California Flats Solar Project

Final Environmental Impact Report

December 2014

Site Plan: Index
 Figure 2-4a
 County of Monterey

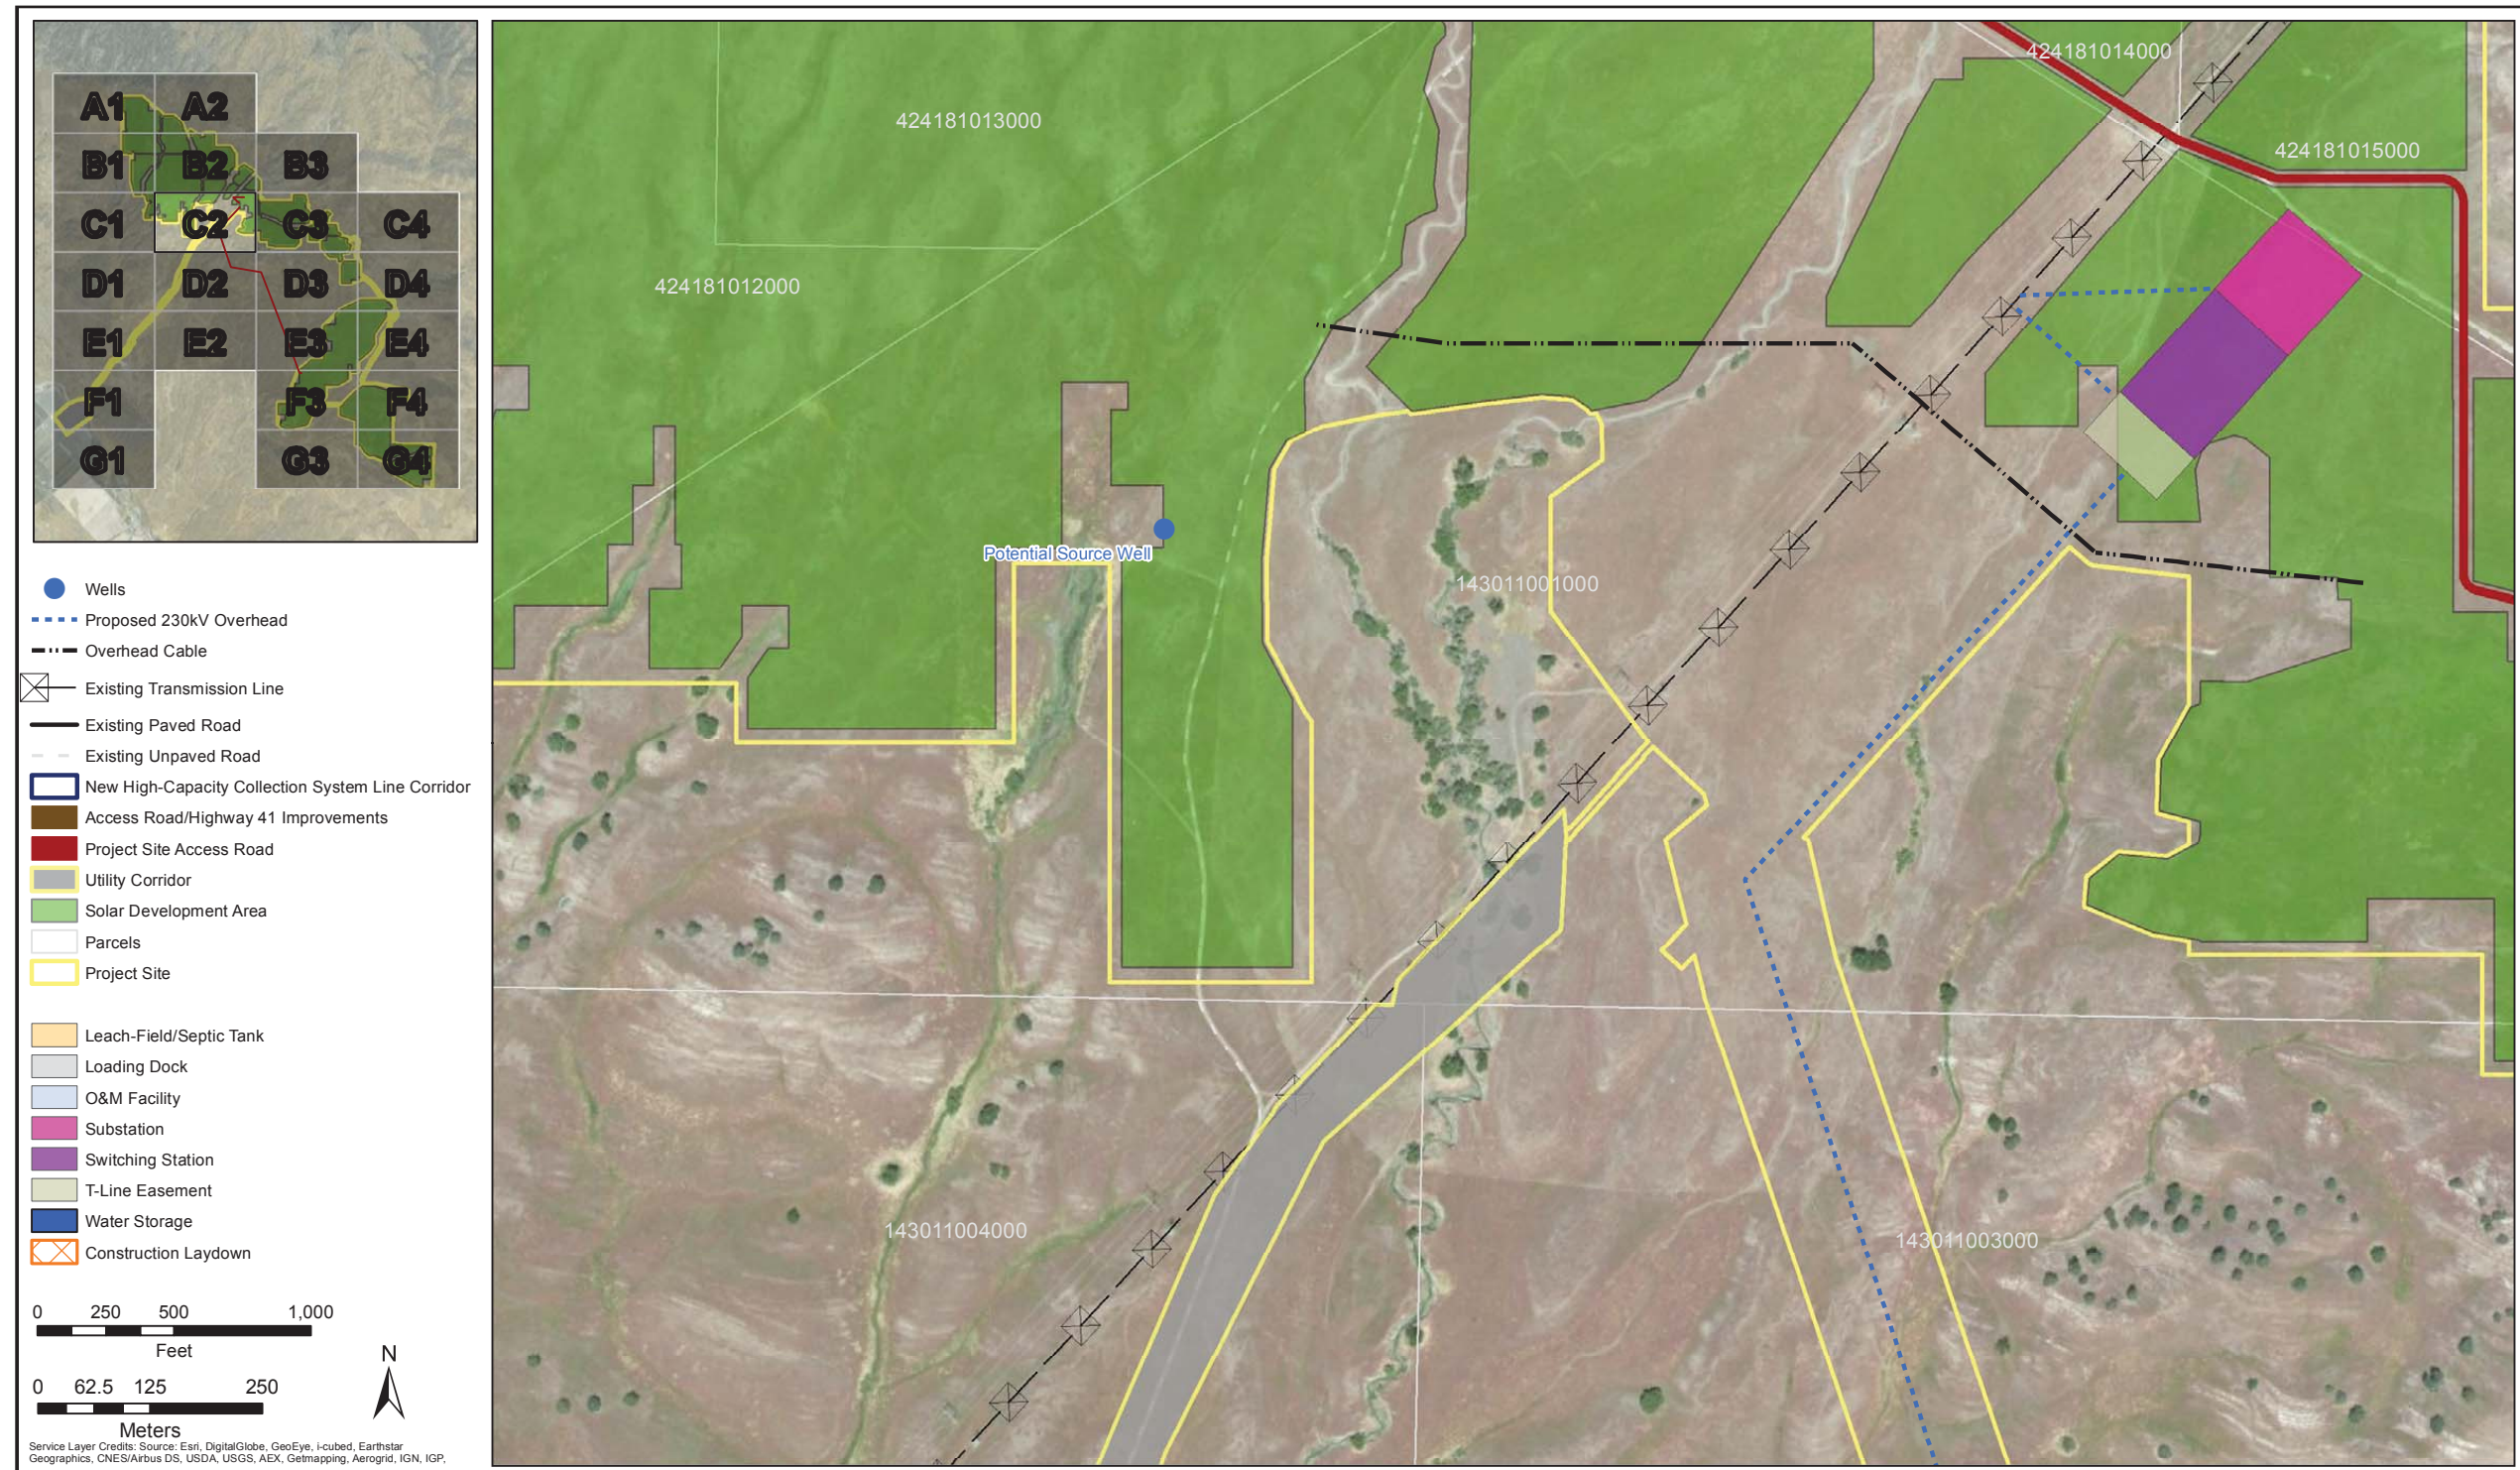
In accordance with these applicant-proposed changes, Figures 2-4a, 2-4e and 2-4f have been revised and replaced with the figures provided following Table 1 in their comment letter. Refer to Section 4.0, *Amendments to the EIR*, for these revised figures.

Figure 4.4-1
County of Monterey

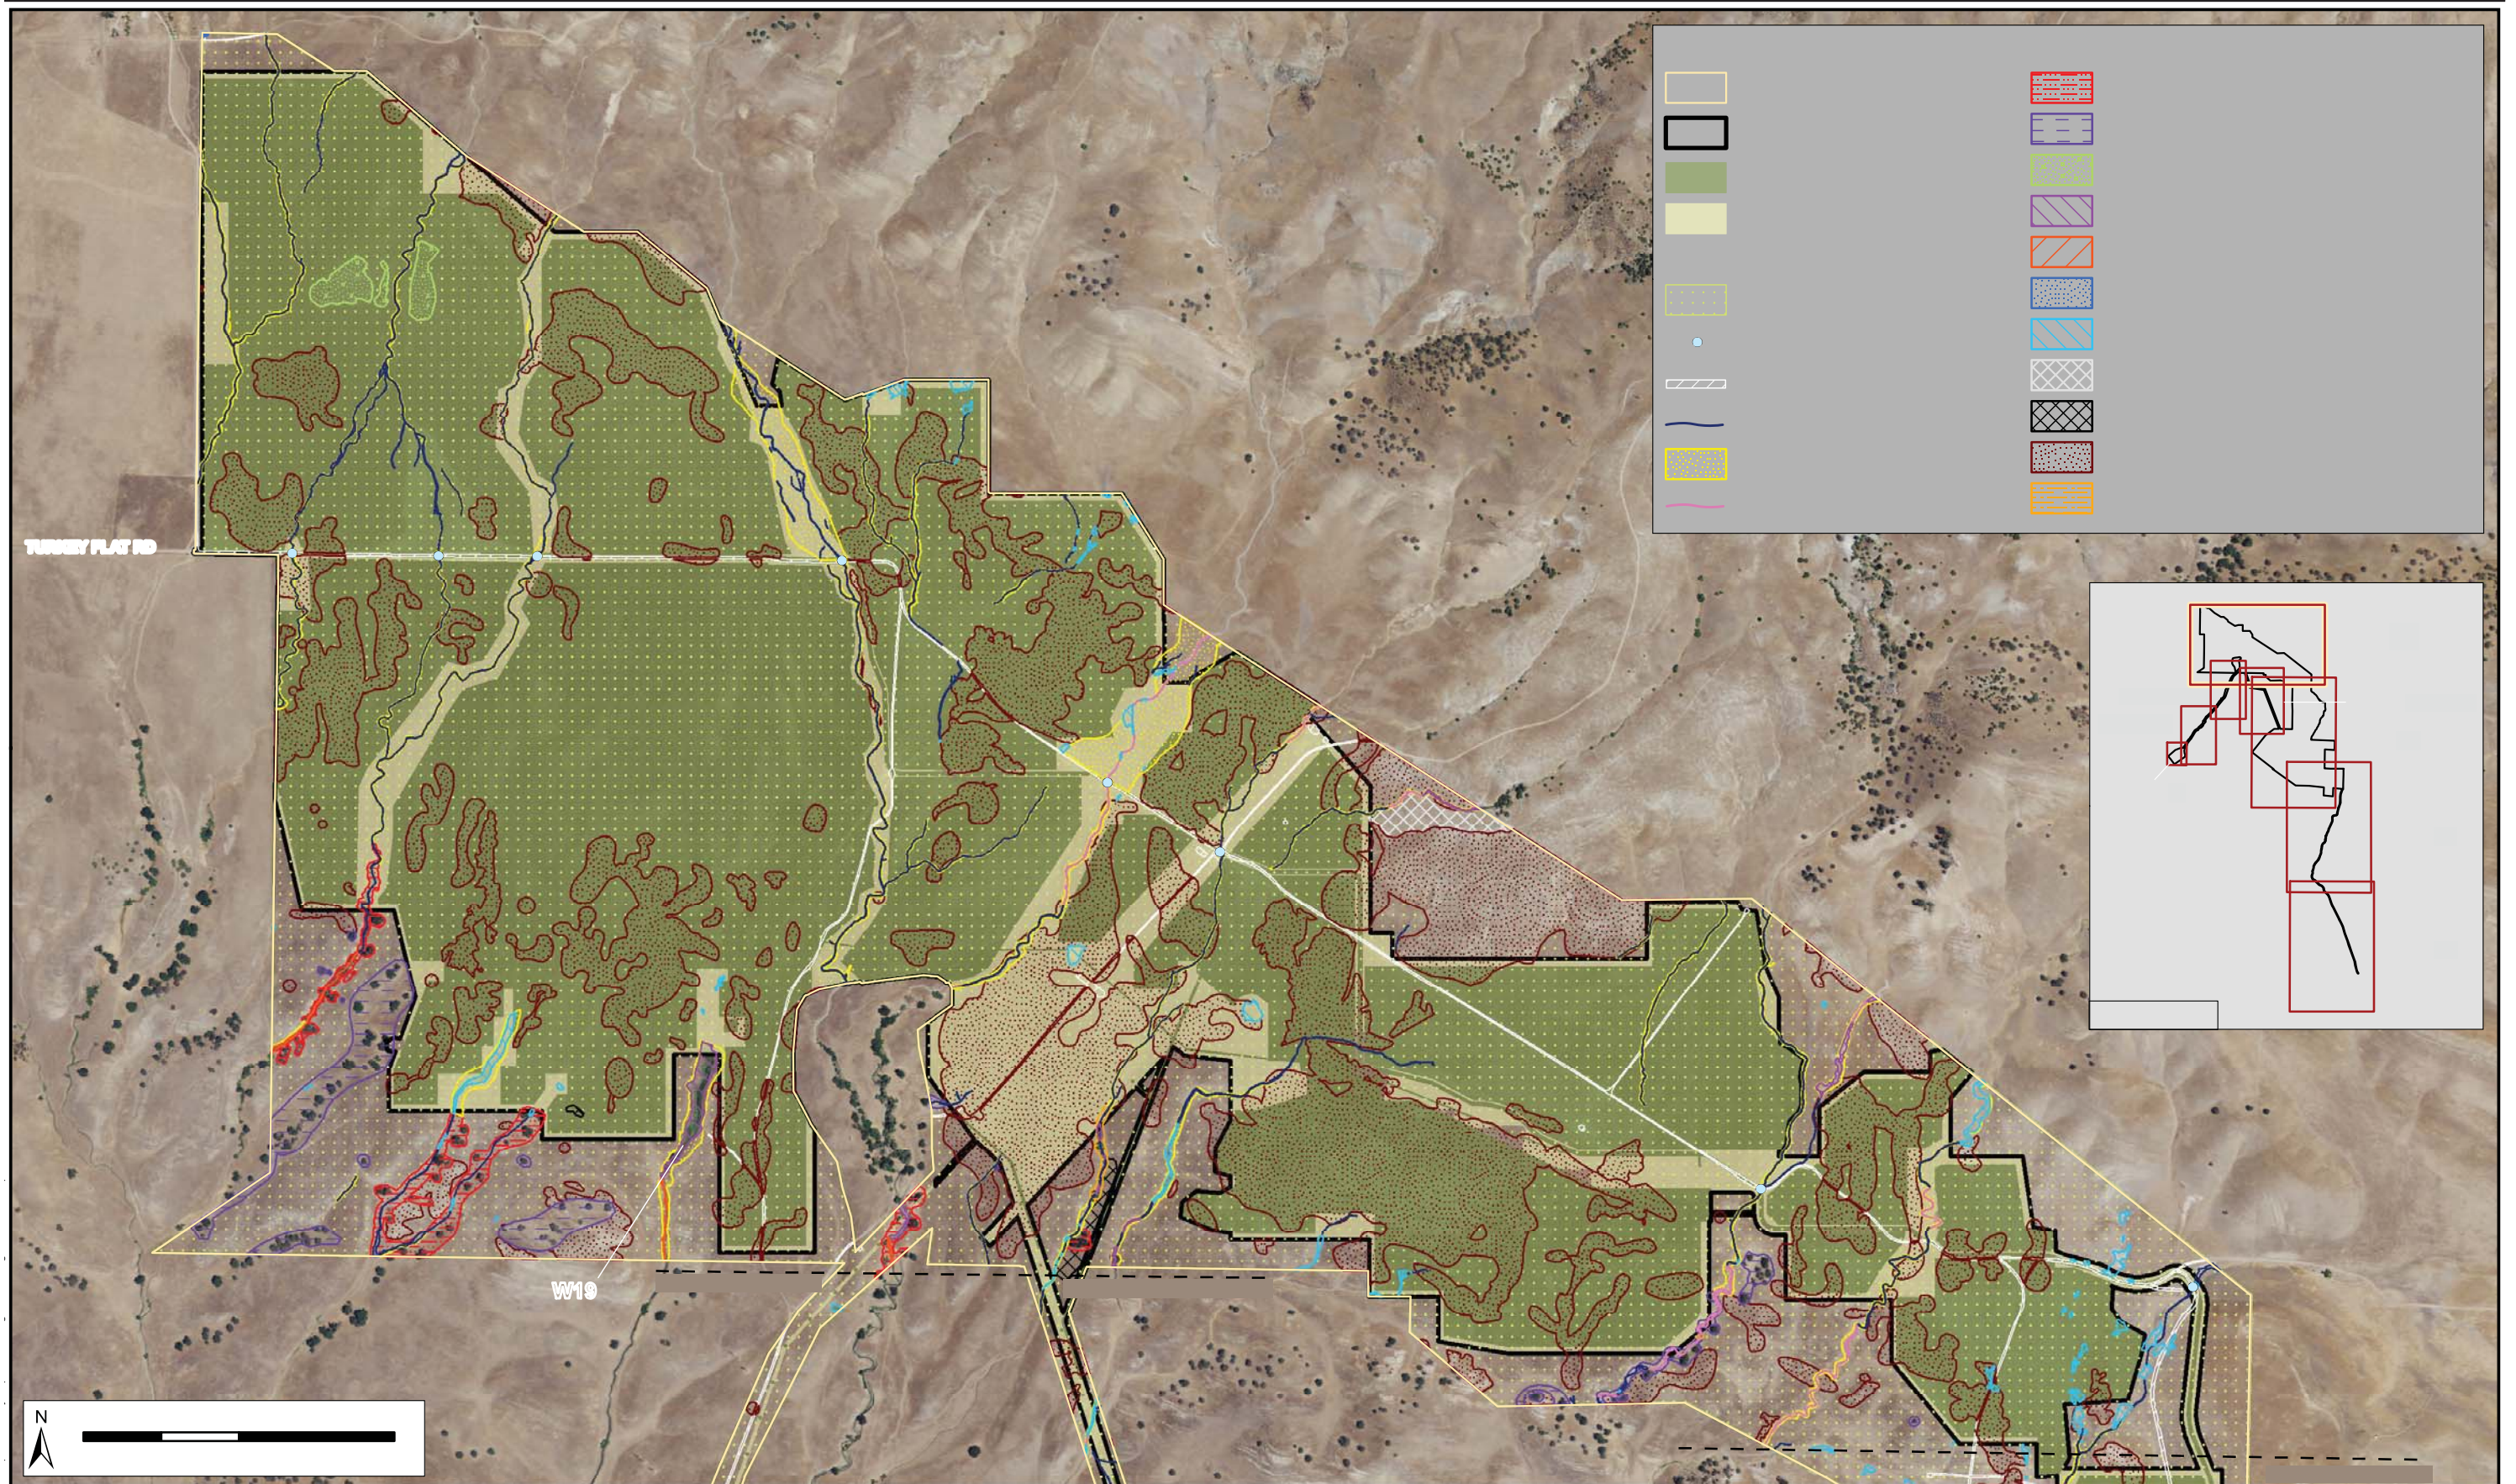
12.	Section 4.4 (Biology)	4.4-13 & 4.4-17 to 4-28	FIGURES 4-4.1 & 4.4-2a to 4-2f	Element Power is incorrectly attributed as having prepared the referenced figures. Please revise these figures to provide the correct attribution as follows: “Source: Amy Sparks (H.T. Harvey & Associates) and First Solar, 2014”.	16.168

Source: Amy Sparks (H.T. Harvey & Associates) and First Solar, 2014

Habitat Map Figure 4.4-2a
County of Monterey

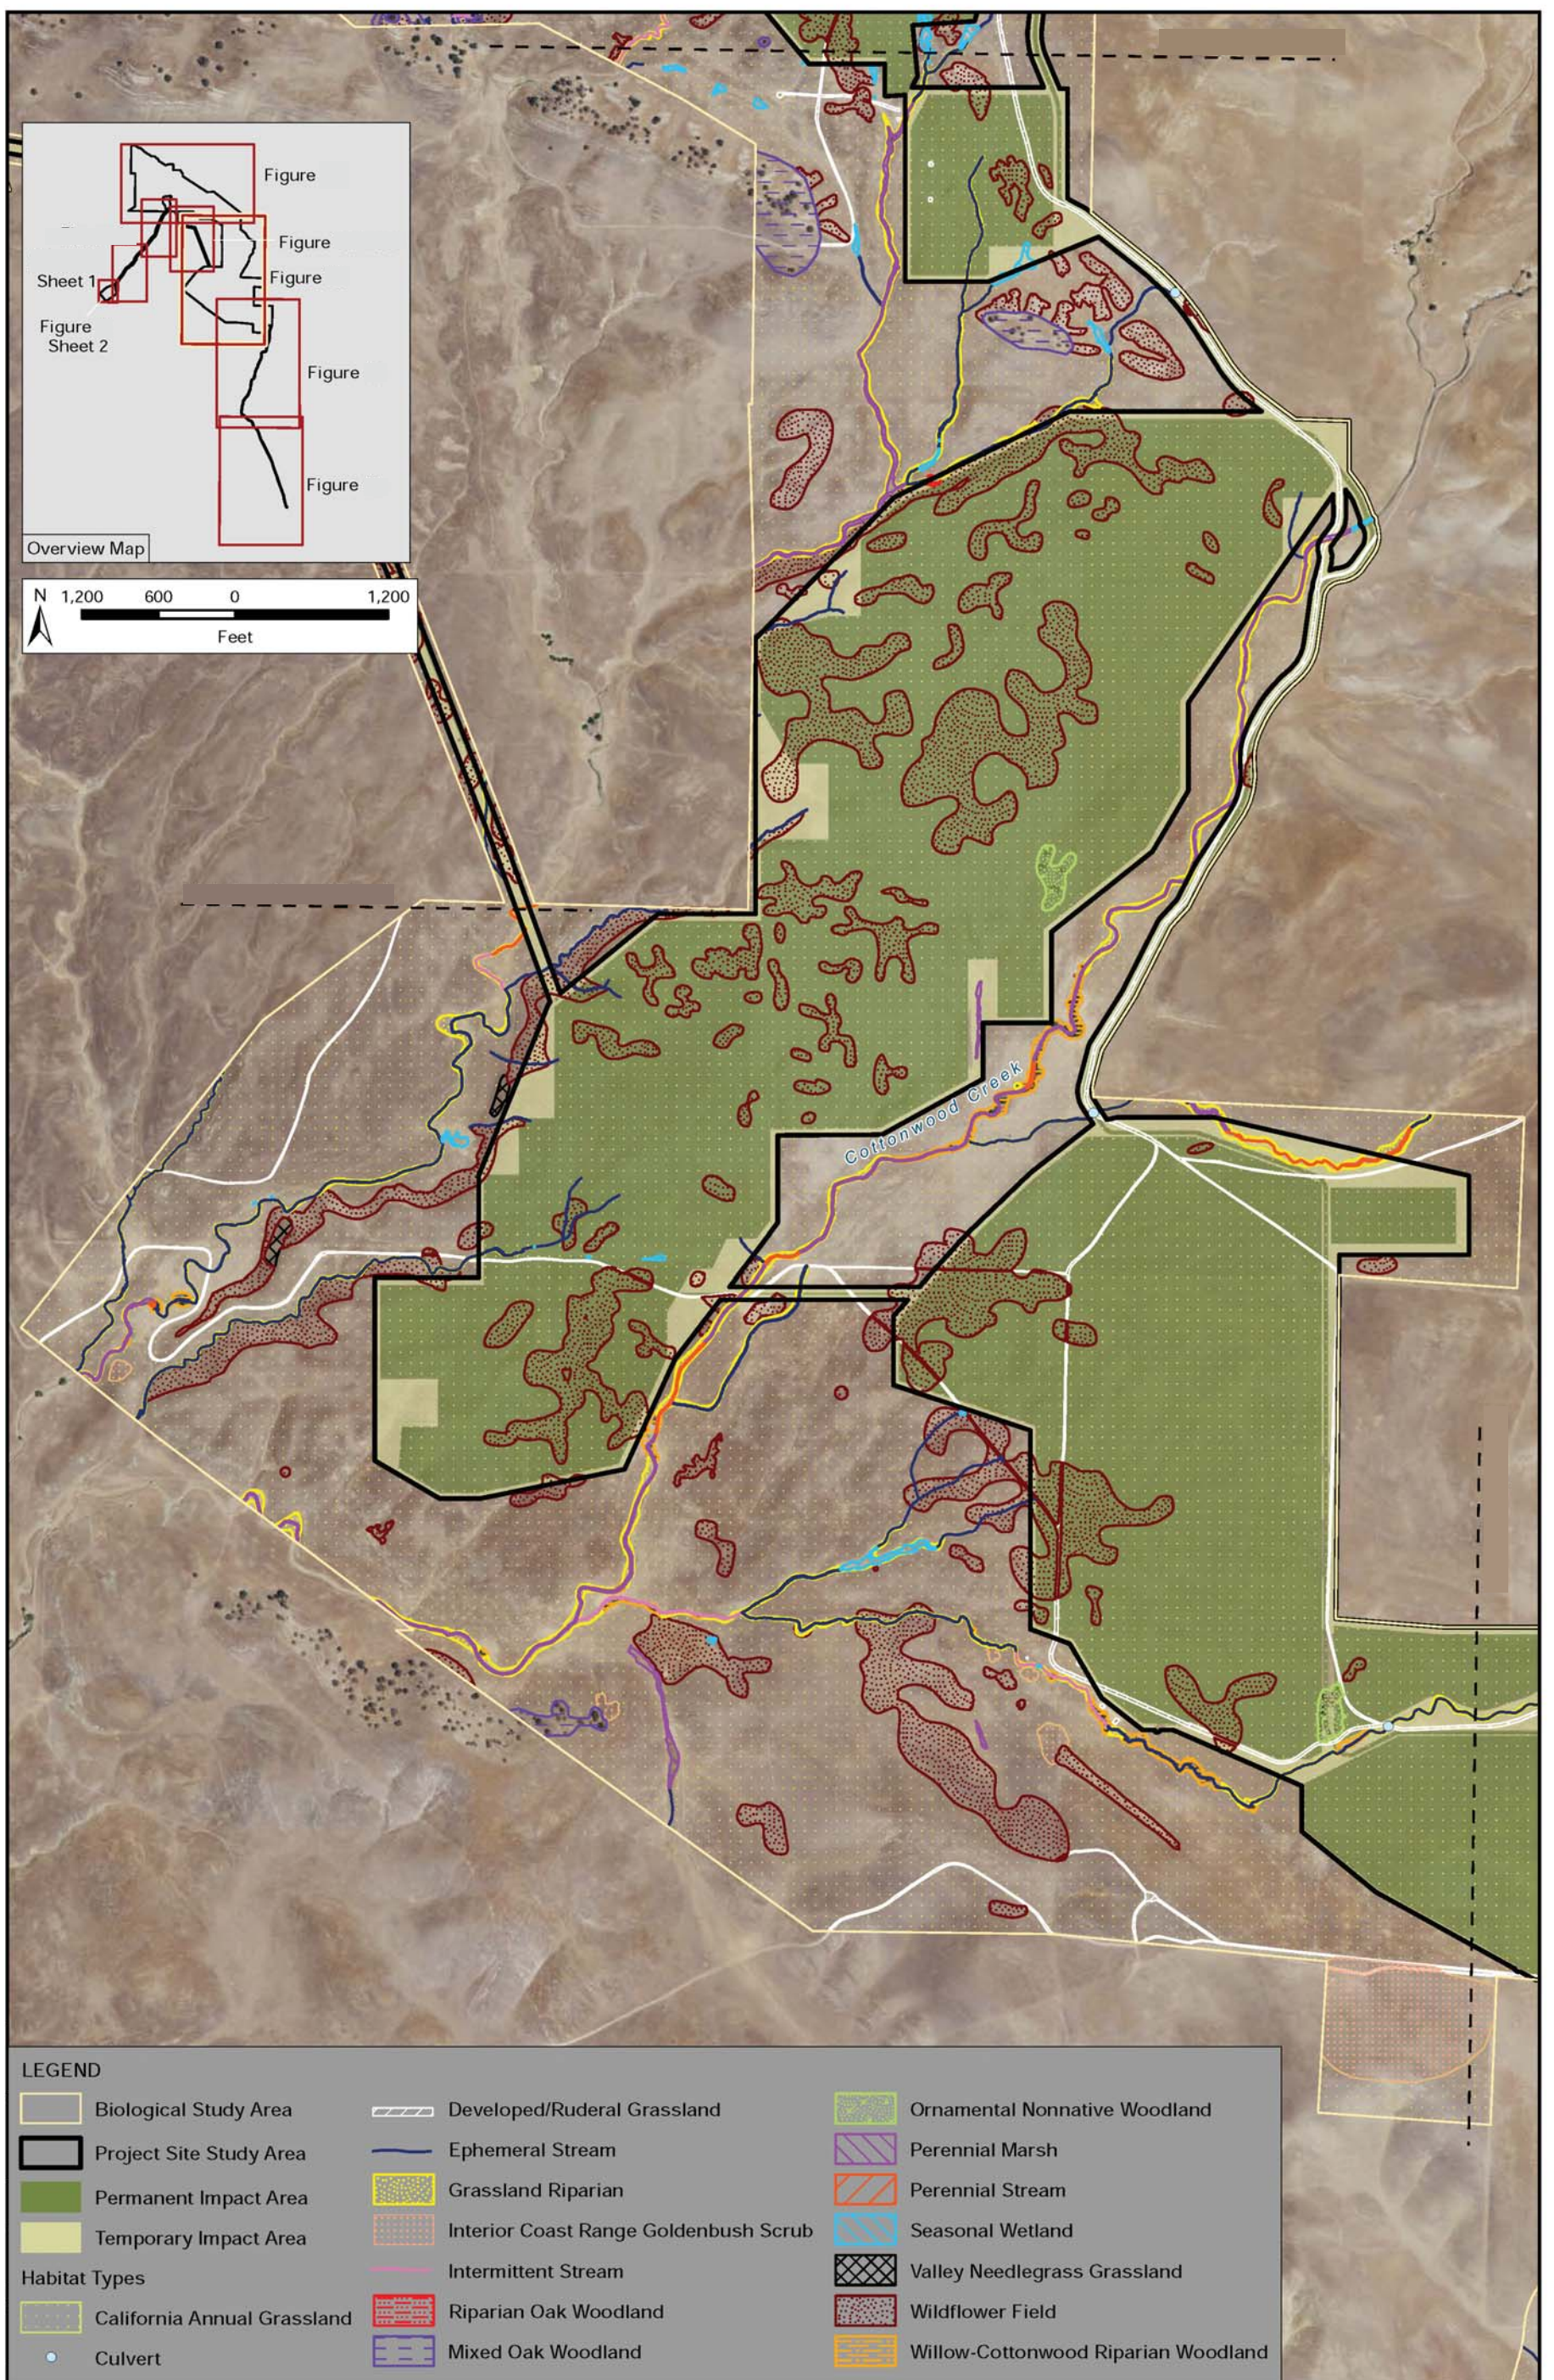
14.	Section 4.4 (Biology)	4.4-33		Section 4.4.2, Aquatic / Wetland Habitats, first paragraph: The first sentence incorrectly uses the term “project site,” when the intended meaning is the “project impact area.” Please revise the first sentence as follows: “Aquatic and wetland features compose a small portion of the BSA, and combined are present on approximately 5.32 acres within the project <u>site</u> impact area (Table 4.4-2; Figures 4.4-2a - 4.4-2d).”	16.170

15.	Section 4.4 (Biology)	4.4-36		Section 4.4.2, Seasonal Wetland, first full paragraph: The first sentence incorrectly references “Figure 3a”. Please revise the first sentence with the correct reference as follows: “. . . watersheds to the northeast (Figure 3a <u>4.4-2a</u>).”	16.171

Figure 4.4-2a through 4.4-2f; revisions shown on the following pages.
